# SERVICE BULLETIN

154 Bulletin 24-03

ELECTRICAL POWER - Modification - Model <sup>2000</sup>~~42-5~~ AMPS, Battery Charger, Incorporate  
Jumper Wire to Satisfy MOD 2 Requirements

Figure 1. Incorporate MOD 3 in Control Board Assembly P/N  
154BS105-1

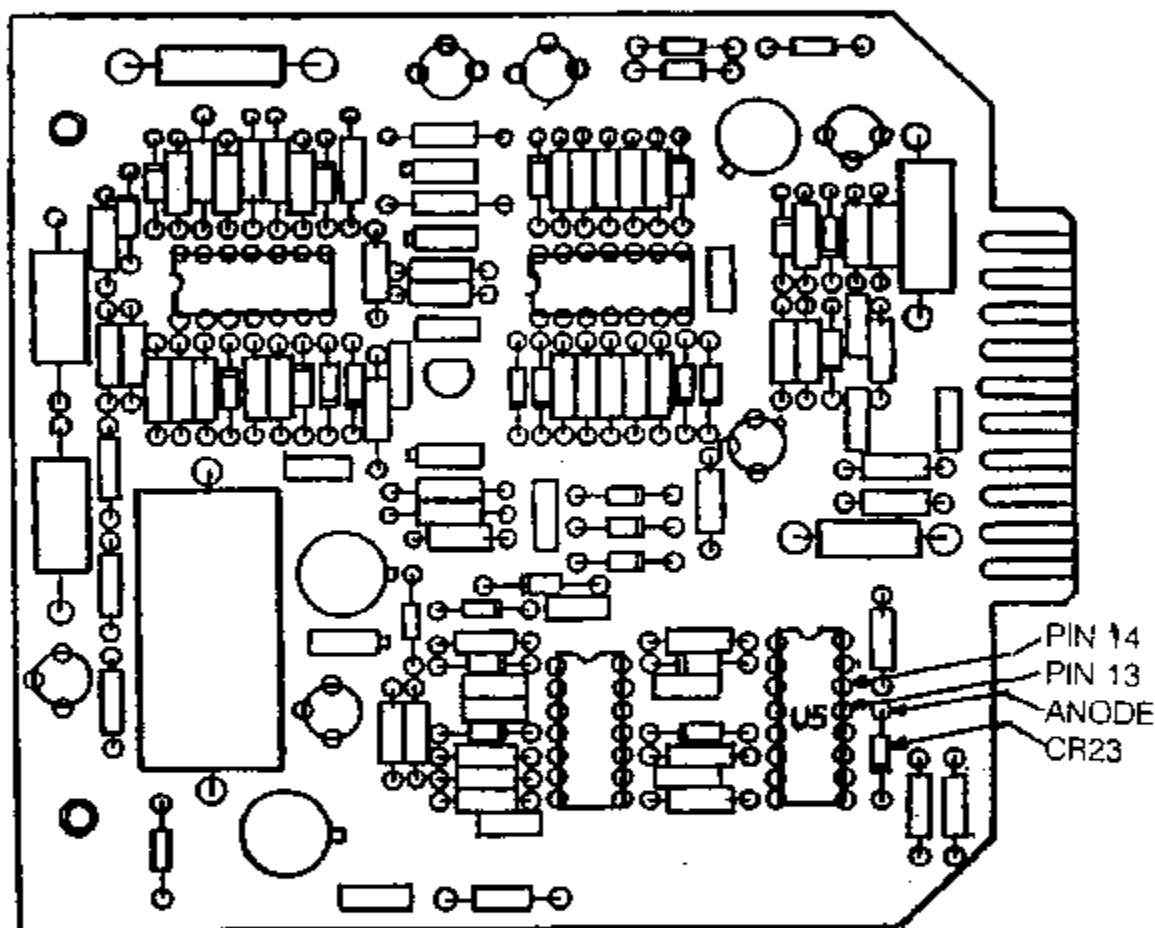
This service bulletin describes the modification required to incorporate a jumper wire from U5, Pin 13 to anode of CR-23.

- (1) Gain access to control board assembly as follows.
  - (a) Remove attaching hardware and cover. Retain hardware for later installation.
  - (b) Disconnect P4 connector from J4 connector (battery pack).
  - (b) Remove attaching hardware and unplug control board assembly. Retain hardware for later installation.
  - (c) Remove control board assembly from the unit.
- (2) Incorporate MOD 2 on control board assembly as follows.
  - (a) Position control board assembly with solder-side up.
  - (b) Locate and cut the trace from U5-Pin 14 to the anode of Diode P/N JANIN4148 (CR23). See Figure 1.

- (c) Solder a jumper wire (28 AWG bus wire) from IC (U5) Pin 13 to the anode of Diode (CR23) in accordance with standard shop practices using solder S/N60 and a soldering iron capable of  $750 \pm 100^\circ\text{F}$ .
  - (d) Touch-up conformal coating around reworked area in accordance with standard shop practices.
- (3) Assemble control board assembly as follows.
  - (a) Assemble control board assembly and secure with retain hardware.
  - (b) Install cover and secure with retained hardware.
